YUCCA MOUNTAIN – SUPPLEMENTAL RESPONSE – REQUEST FOR ADDITIONAL INFORMATION (RAI) –VOLUME 2, CHAPTER 2.1.1.4, SET 3 (DEPARTMENT OF ENERGY’S SAFETY ANALYSIS REPORT SECTION 1.7) – Identification of Event Sequences

RAI Volume 2, Chapter 2.1.1.4, Third Set, Number 1, Supplemental Question 5:

Response Tracking Number: 00409-03-00

RAI Volume 2, Chapter 2.1.1.4, Third Set, Number 1, Supplemental Question 7:

Figure 1. Subsurface Repository Intake and Access Mains

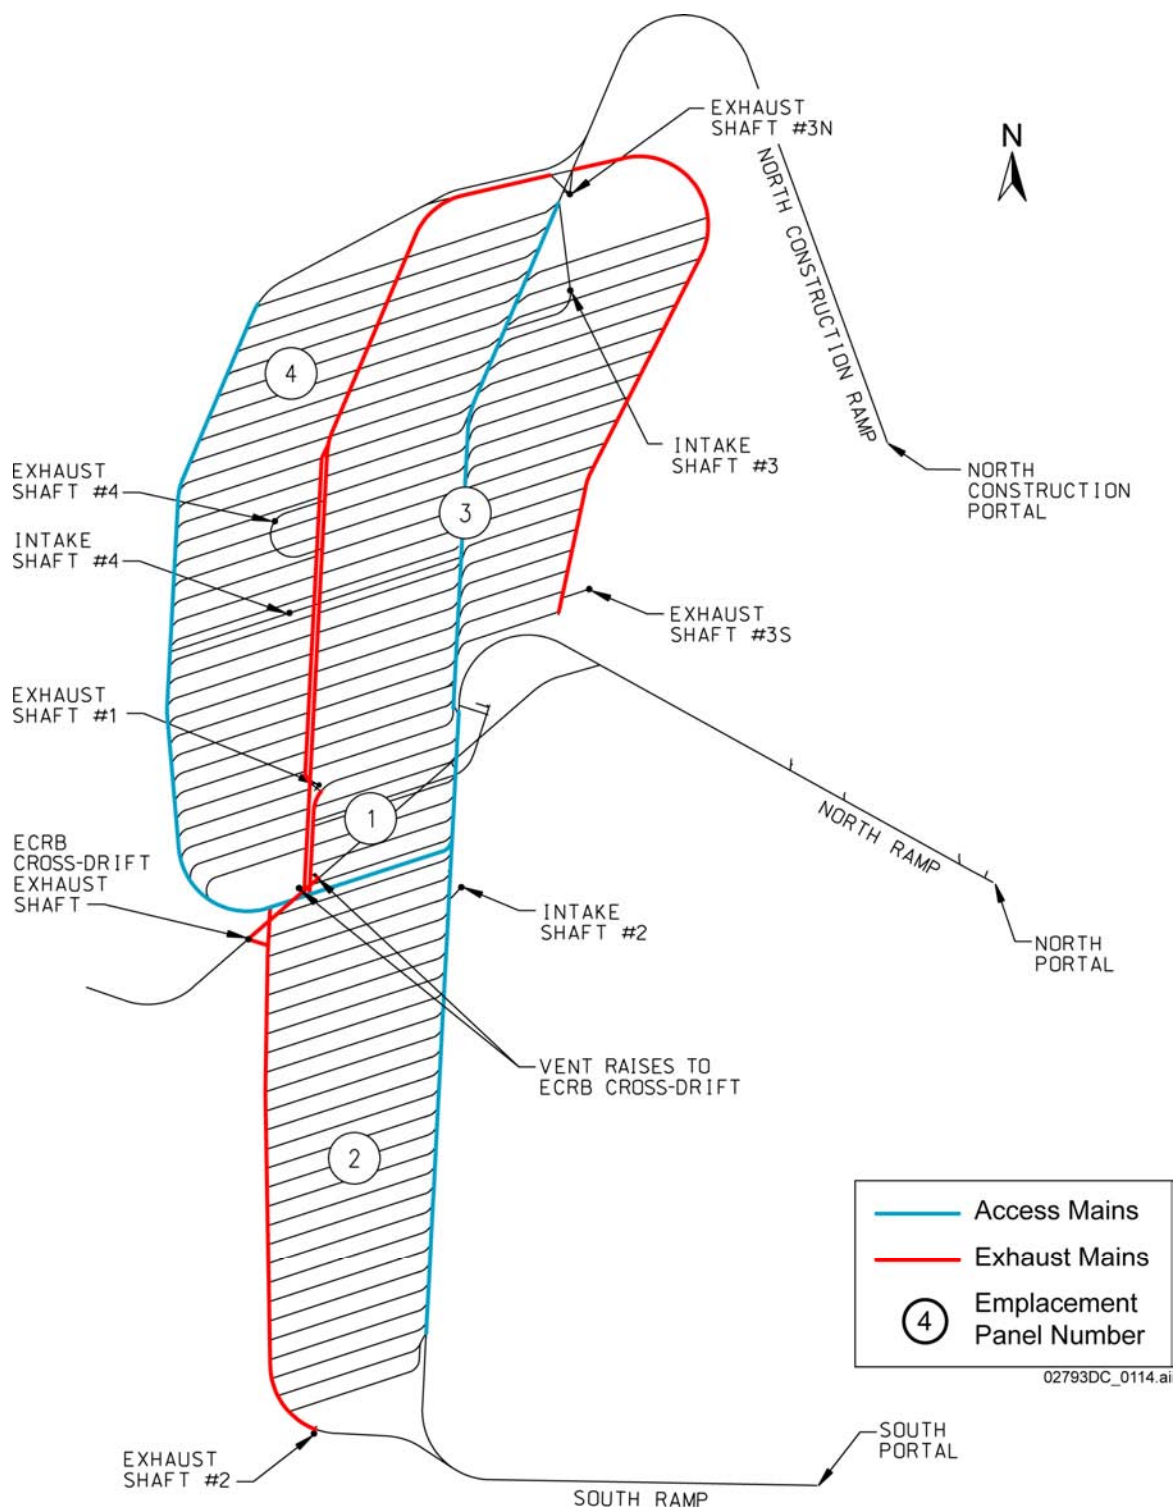
Clarify the DOE's plan for ensuring sufficient air flow through the ventilation exhaust system if one or more openings used for exhaust air flow (e.g., on exhaust main or shaft) were to be blocked due to rock collapse.

The underground layout configuration is a modular design that provides flexibility to meet thermal goals (SAR Section 1.3.1.2.5), and provides the capability for alternate ventilation airways using the existing openings, should one of the airways fail. Exhaust shafts have been positioned at the ends of each panel, except in Panel 1, to provide for diversion of the airflow if required (Figure 1). The subsurface layout ventilation components, consisting of three shafts and three ramps on the intake side and six shafts on the exhaust side, provide a minimum of 20% extra capacity overall (BSC 2003, Section 8.6).

Fully Emplaced Repository—Except for Panel 1, the design of the subsurface layout provides for multiple exhaust shafts in each emplacement panel, which are typically located at the northern and southern ends of each panel. In addition, the exhaust airway drifts are interconnected where possible and the shaft access drifts are designed to accommodate airflows from different sources (Figure 1). For example, the Panel 3 and Panel 4 Exhaust Main is a continuous excavation with Exhaust Shaft #3N configured to exhaust air from Panels 3E, 3W, and 4. Exhaust Shaft #3S provides a second exhaust airway at the south end of Panel 3E. Exhaust Shaft #4 is configured to exhaust air from Panels 3W and 4, and the Enhanced Characterization of the Repository Block (ECRB) exhaust shaft can exhaust air from Panels 1, 2, 3W, and 4. The Panel 2, 3W, and 4 exhaust airflow paths are connected via the ECRB cross-drift and internal raises.

Initial Emplacement for Panel 1—The initial emplacement will occur in Panel 1, in the central part of the overall subsurface layout. Exhaust Shaft #1 is the only exhaust source for initial emplacement in Panel 1, and in the event that Exhaust Shaft #1 is unavailable during the initial development and emplacement phase, the ECRB exhaust shaft could be reconfigured as the alternate exhaust airflow route. The ECRB exhaust shaft is constructed prior to initial waste emplacement to provide intake air to the second phase of construction via an internal raise (SAR

Figure 1. Peak Midpillar Temperature (°C) Over Each Seven-Waste-Package Segment for the Estimated Limiting Waste Stream.

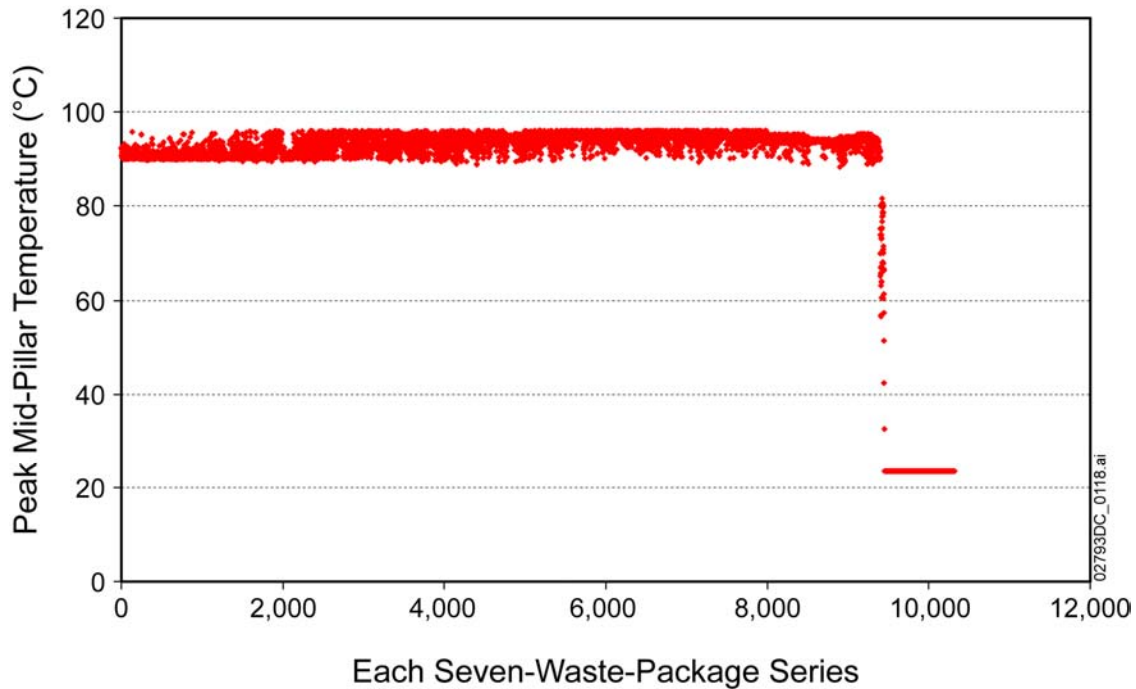
To clarify DOE's plan to ensure sufficient ventilation of waste packages to meet repository thermal limits, provide documentation that shows the calculations and methodology to obtain local and overall average thermal line loads, in enough detail to enable a review of the estimated limiting waste stream average line load in SAR Figure 1.3.1-6.

To evaluate the range of local average thermal line loads in the repository, emplacement of the estimated limiting waste stream in the subsurface was simulated by using a postprocessing algorithm for the total system model output. For this purpose, an index of thermal energy density was developed specific to each commercial SNF and codisposal waste package, and the waste packages were emplaced so that a running average of this index was less than a prescribed limit (SNL 2008, Section 6.1.3). The thermal energy density for a single waste package is that thermal energy content that results in the peak midpillar temperature if the entire repository was loaded with waste packages with identical thermal decay histories, and is therefore described in terms of the midpillar temperature. The running average is then an estimate of the local peak midpillar temperature, calculated with the thermal energy densities for all the waste package types represented in a given drift segment. As stated in SAR Section 1.3.1.2.5, approximately half of the individual waste packages in the estimated limiting waste stream have an index of thermal energy density that exceeds the limit of 96°C. Therefore, those waste packages must be emplaced with, and proximal to, cooler packages so that the estimated local peak midpillar temperature is 96°C or cooler based on a running average over a seven-waste-package segment.

The postprocessing algorithm for the total system model kept track of the commercial SNF delivered to the repository and placed into surface storage for either fuel staging or aging, and then, at each loading opportunity, selected the waste package giving a running average value closest to the 96°C limit. Two other constraints were also imposed on commercial SNF waste package segments to control preclosure temperatures in the event of temporary loss of forced ventilation, as follows (SAR Section 1.3.1.2.5):

The emplacement drifts were loaded with waste packages, one at time, yielding a sequence of more than 10,000 waste packages that was examined to find the hottest seven package segments (SNL 2008, Section 6.1.4). The maximum local average thermal line load of 2.0 kW/m at
